# Access Compliance Report

## Public Rights-of-Way

### (Curb Ramps)

Intersection ID: 8537	Main Street: BEATTIES_FORD_RD	Cross Street: ST_LUKE_ST	Location: NE
ADA ID: 5F08C45172C9	Ramp Type: BlendTrans1	Initial Pass/Fail: Fail	Overall Compliance: No
			Severity Score: 21.25

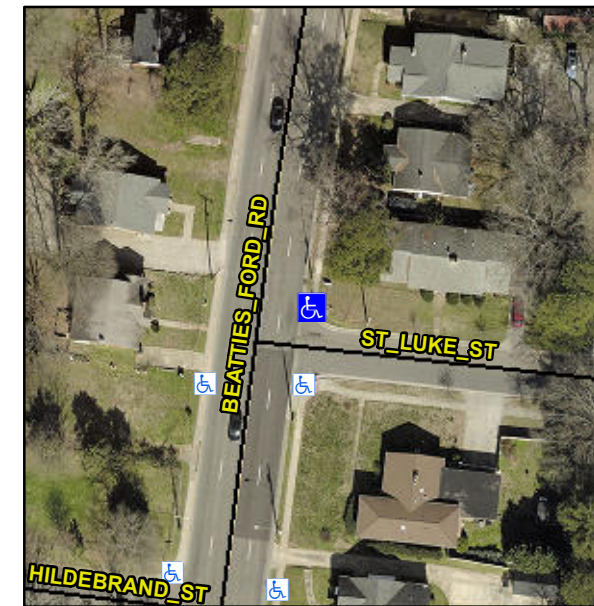
**NO RT SW**

**R304.5.1, R304.5.3**

**Remove & Replace Curb Ramp With Two New Directional Ramps or Equivalent.**
